Access Compliance Report

Public Rights-of-Way

(Curb Ramps)

Intersection ID: 2419	Main Street: LAUREL_RUN_DR	Cross Street: WILDBROOK_DR	Location: W
ADA ID: 599AC4590167	Ramp Type: PerpDiag	Initial Pass/Fail: Pass	Overall Compliance: No
Codes/Mitigation Info/Possible Solution		Field Measurements/Component Compliance	
		Severity Score: 14

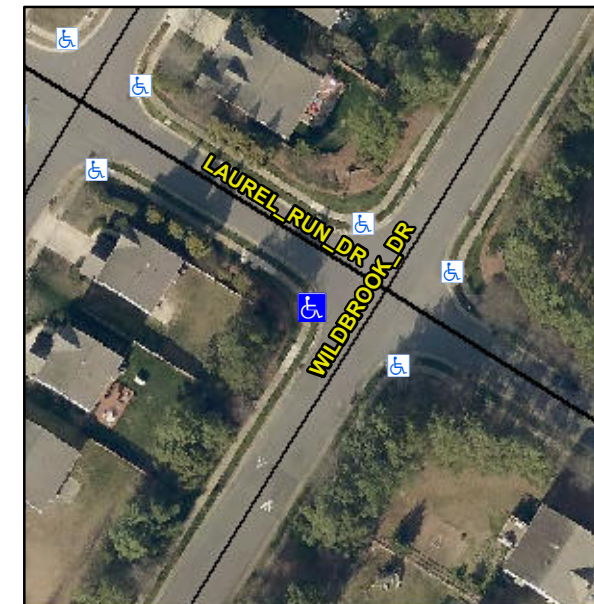
Remove & Replace Curb Ramp With Two New Directional Ramps or Equivalent.

R304.2.1, R304.2.2-Perp, R304.3.2-Para, R305
